**From:** Neil Duffield  
**Sent:** 31 January 2019 17:13  
**To:** Hilary Saunders  
**Subject:** NYM/20108/0653/FL St Athanasius Monastery Langdale End E62 NYMNP details 31-01-19

- Elliot Consultancy Arboricultural report using new topographical survey showing full extent of trees
- D11161-02F, Floor Plans showing minor design alteration, windows to Lower ground
- D11161-03H, Elevations, added windows also materials to externals altered.
- D11161-04B, Revised existing topographical survey produced to show further trees as noted in Astute Ecology Report
- D11161-05E, Proposed Block Plan/Topo, building moved to prevent encroachment on Car Park
- D11161-06B, Amended site sections following building position change
- D11161-07A, Car Parking drawing

CLIENT:	Coptic Orthodox Patriarchate		
PROJECT:	New church at St Athanasius Monastery		
Drawing:	Proposed Plans		
DRAWING STATUS:	Preliminary		
DRAWN:	C Eynon	CHECKED:	N I Duffield
SCALE @ SIZE:	1:100@ A1	DATE:	18/12/17
DRAWING No:	D11161-02		REV: F

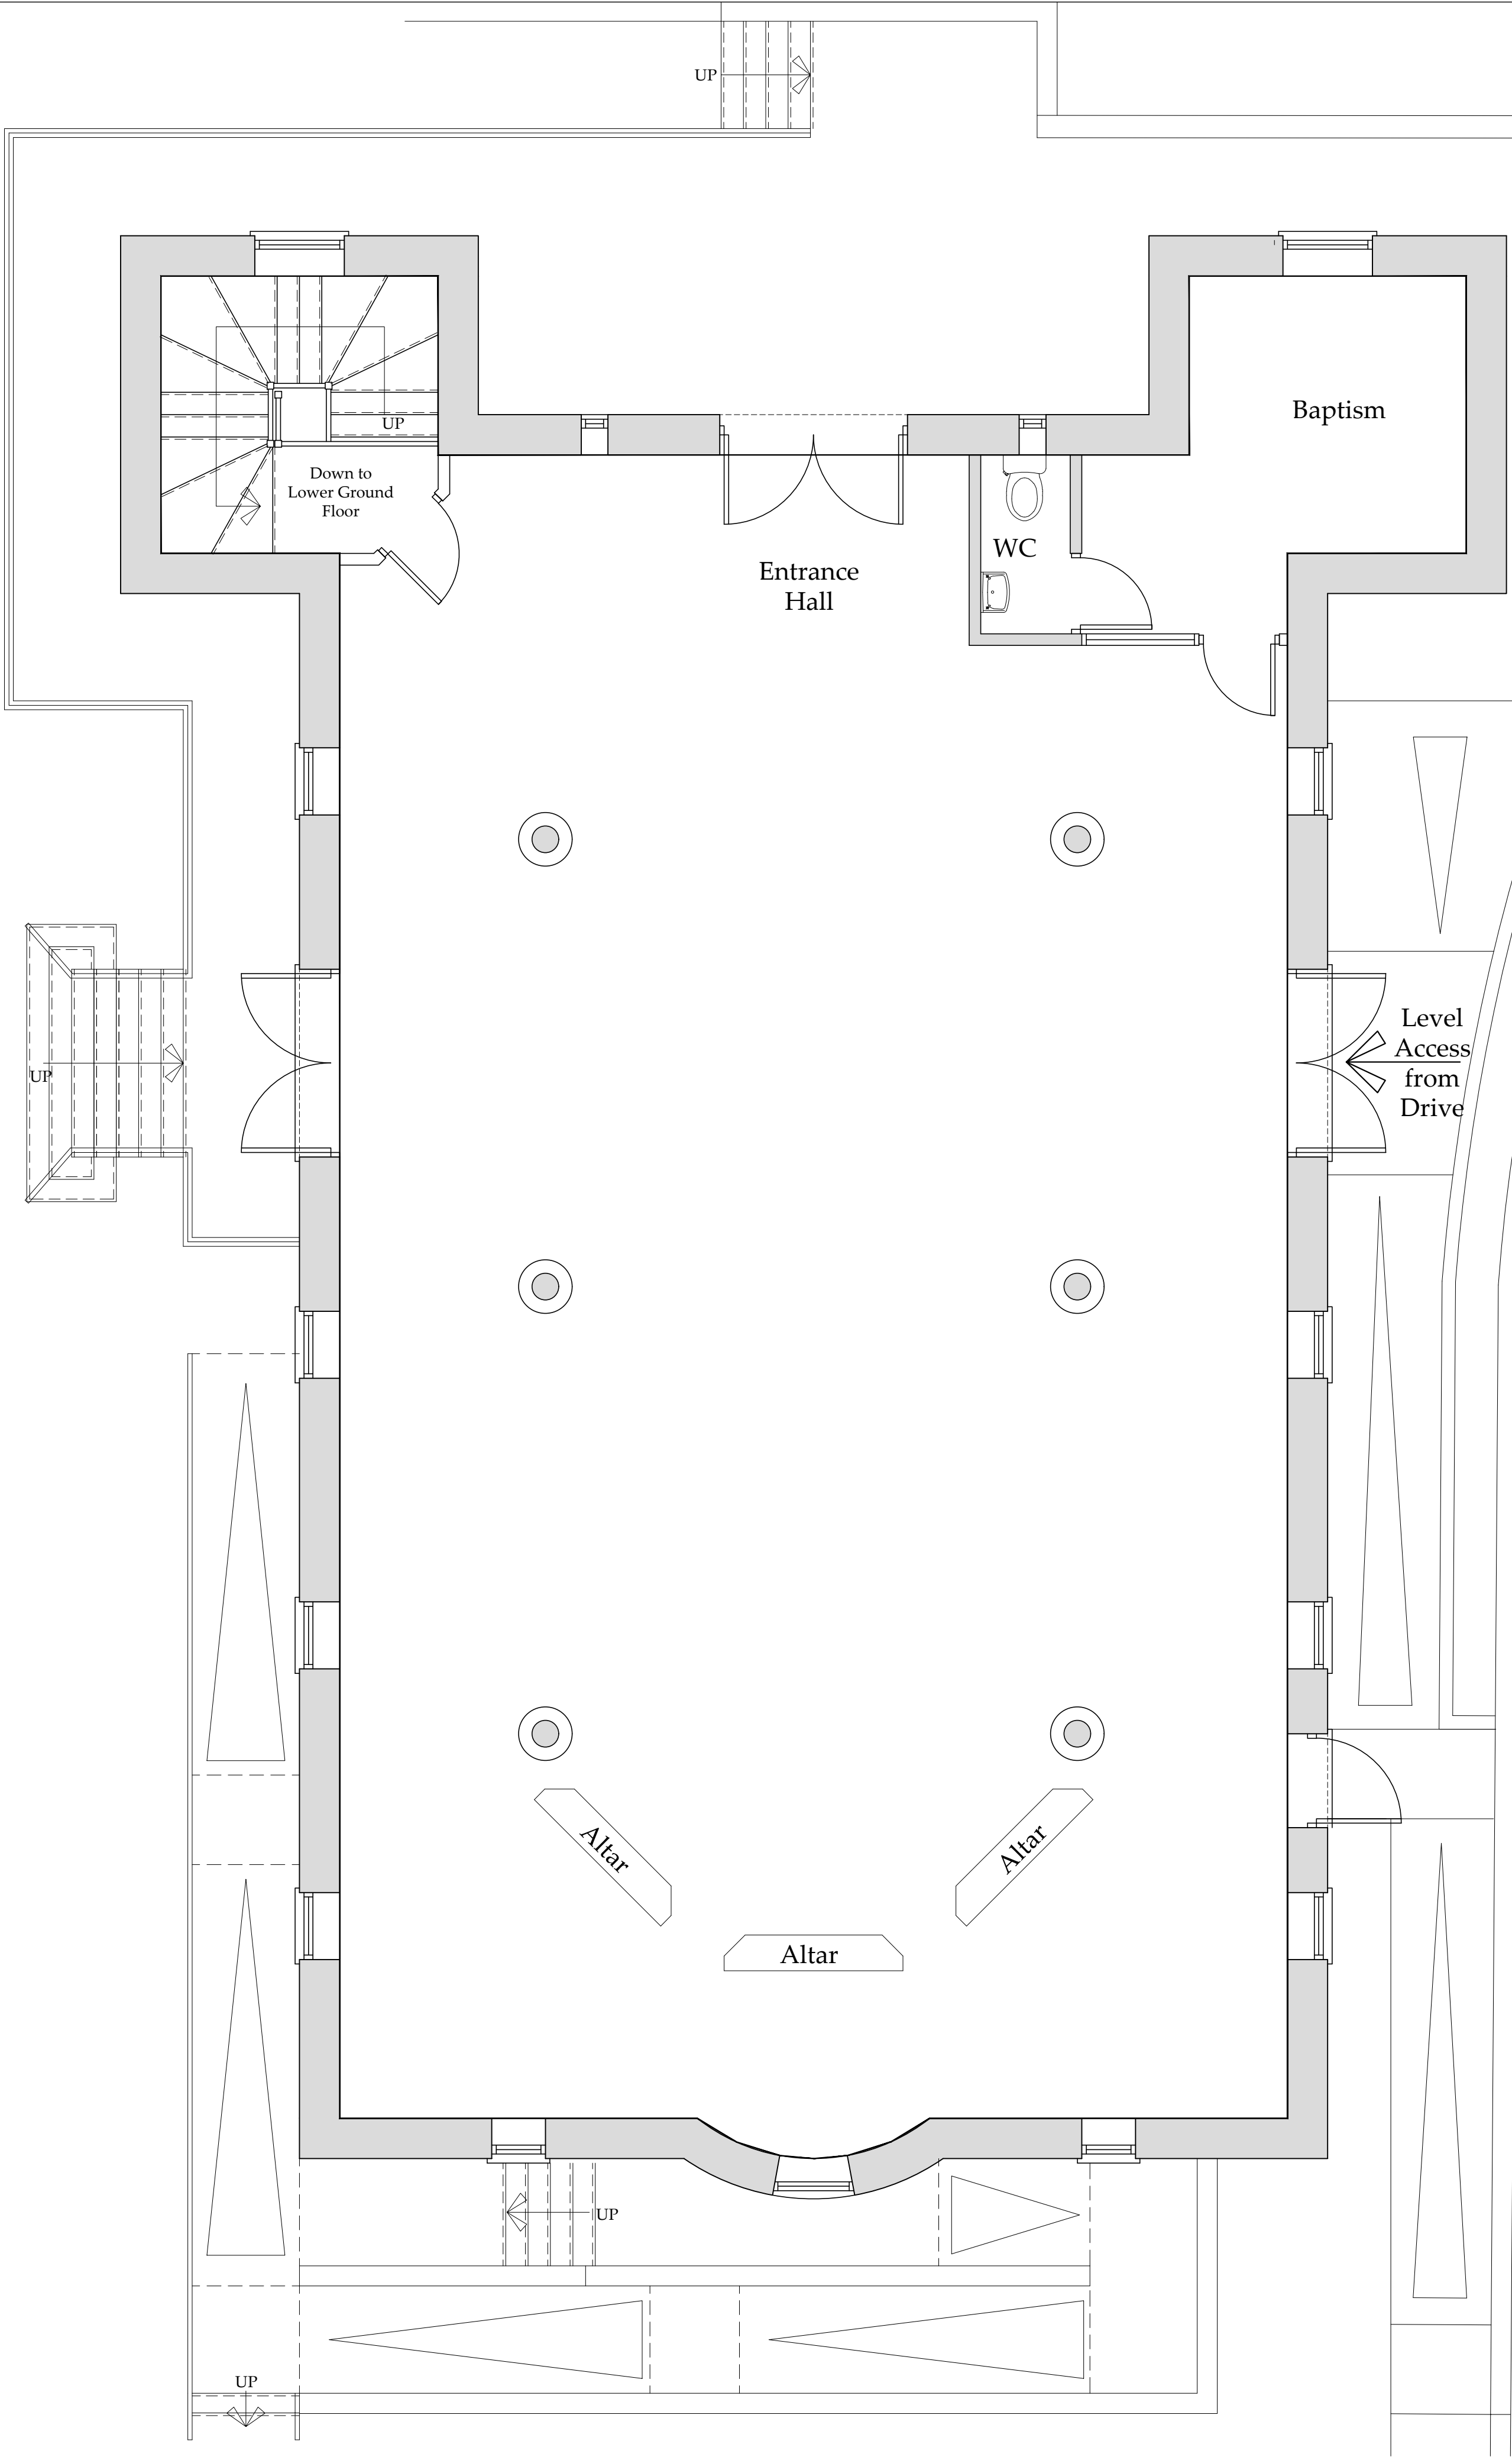
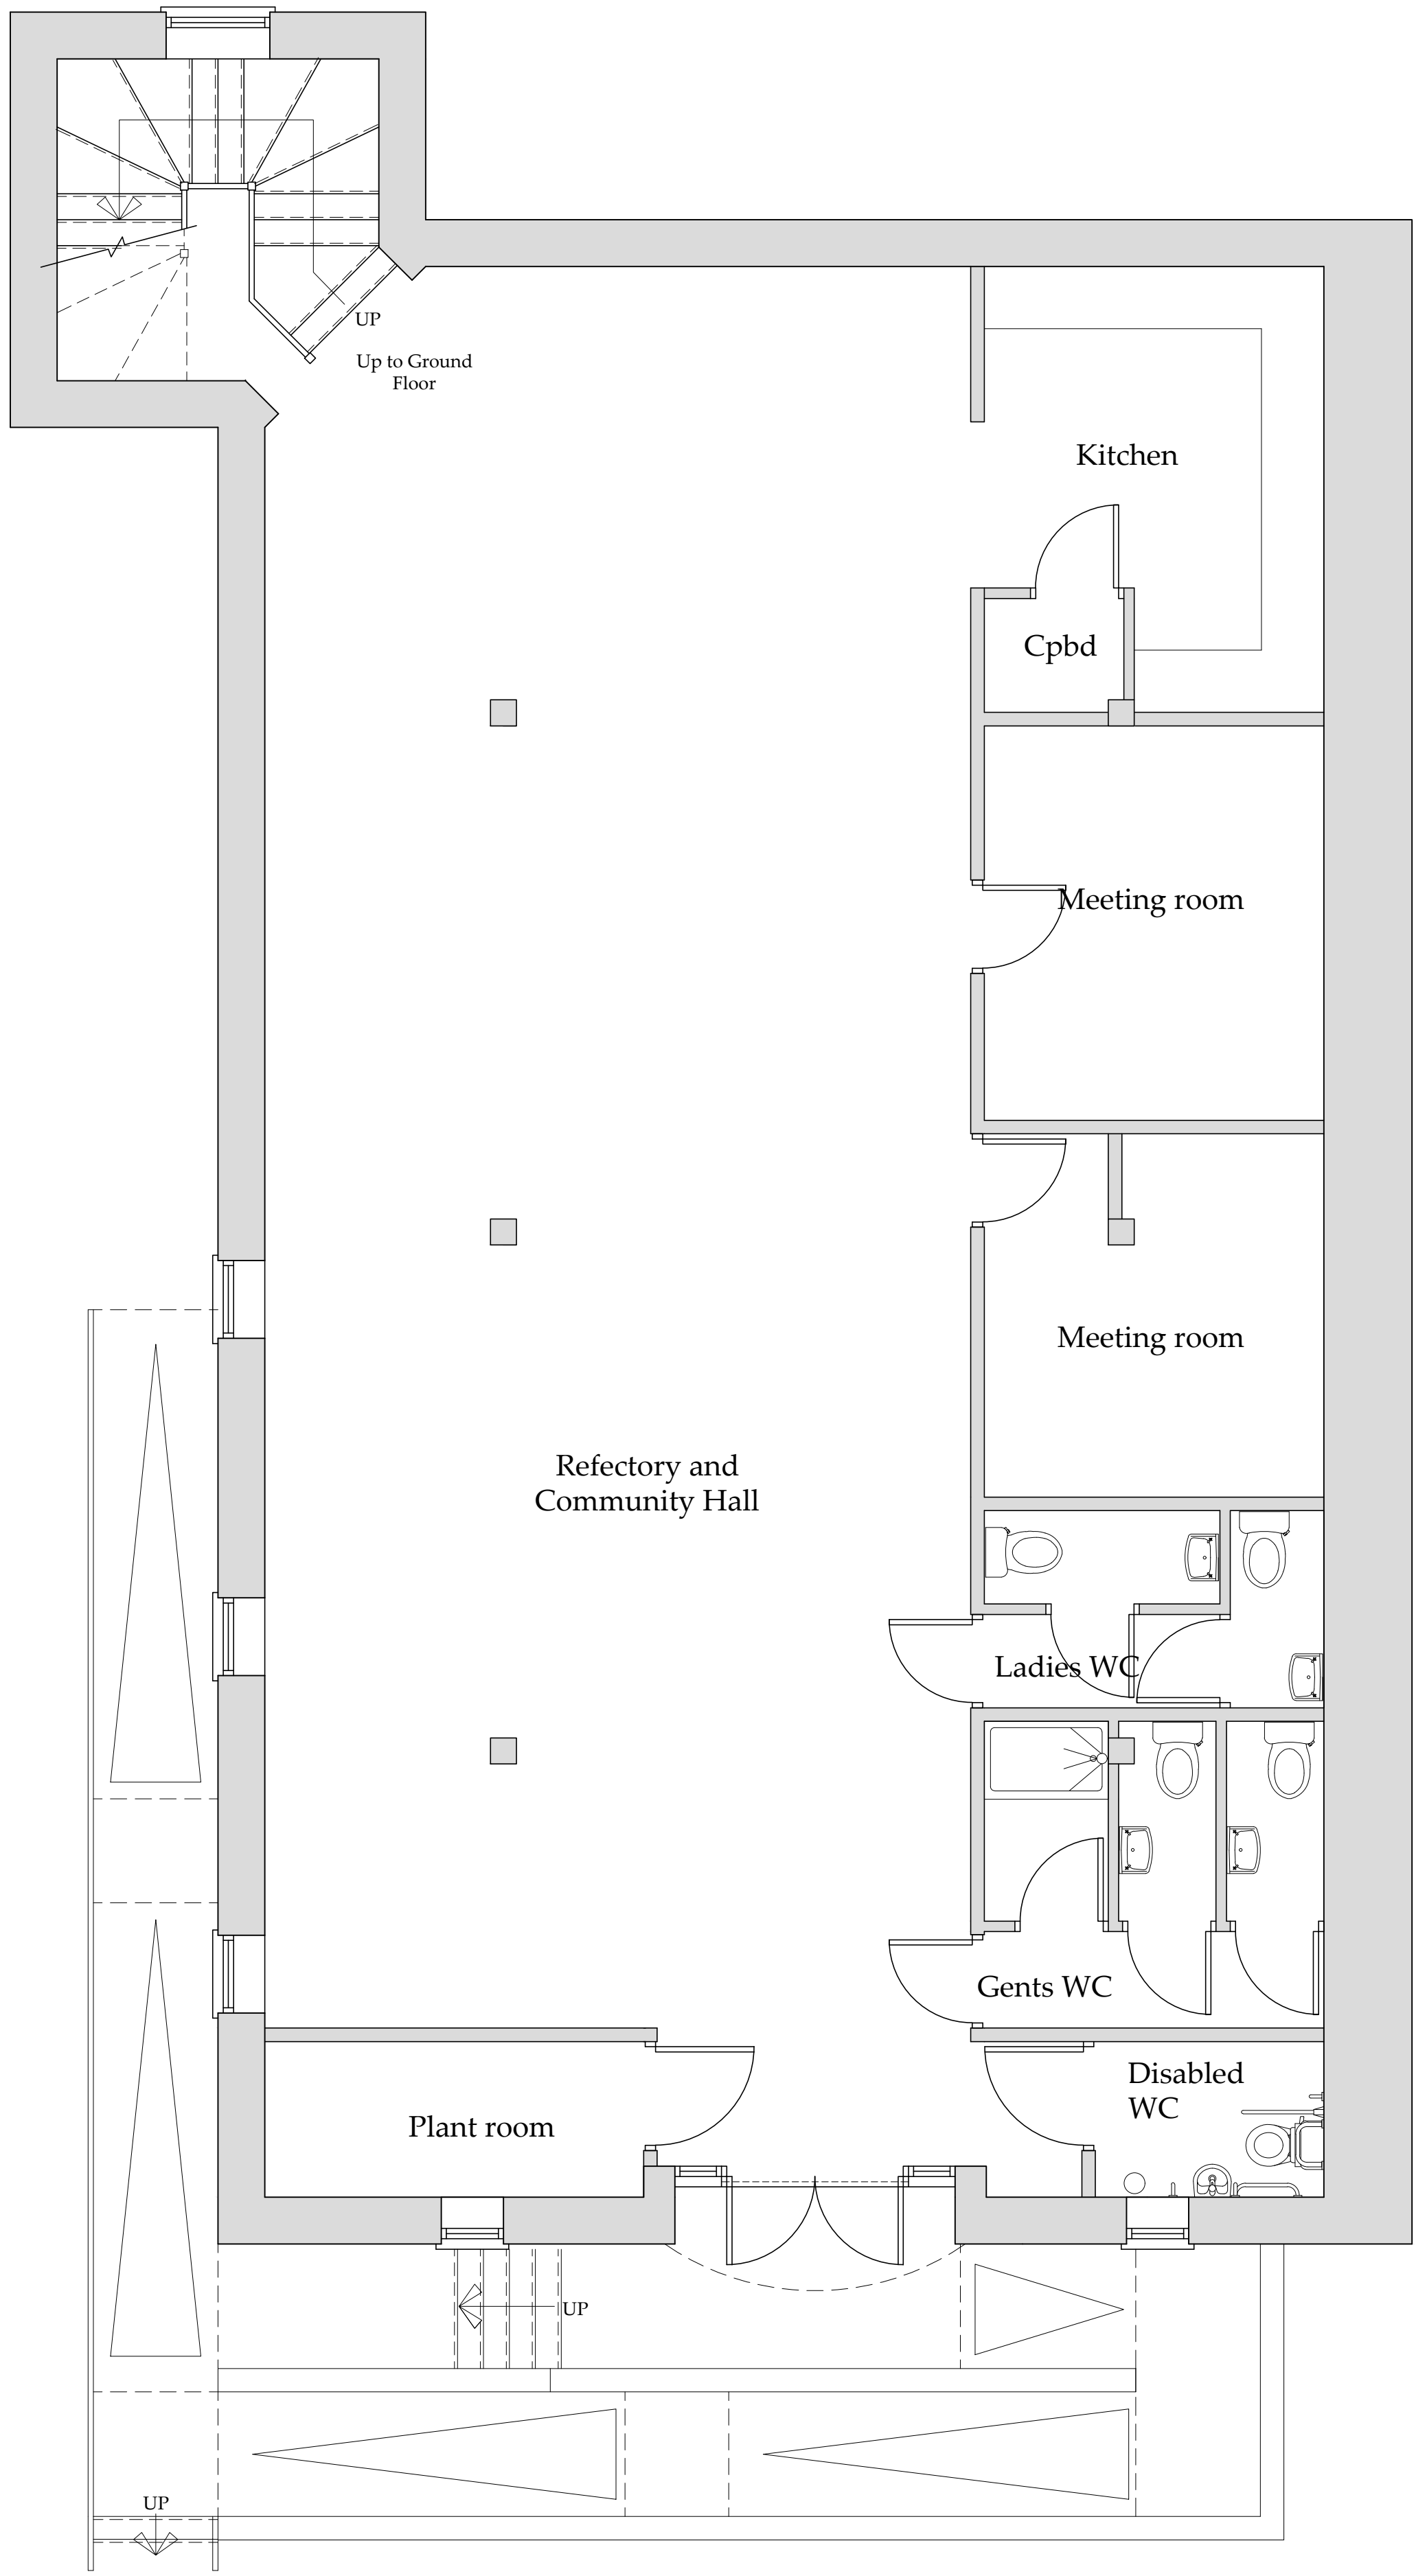
F	22/01/19	CE	Lower ground floor windows added
E	15/01/19	CE	Building moved
D	24/08/18	CE	Issued for planning
C	12/06/18	CE	Amended to suit clients
B	18/05/18	CE	Amended to suit client
A	18/12/17	CE	Issued for Approval
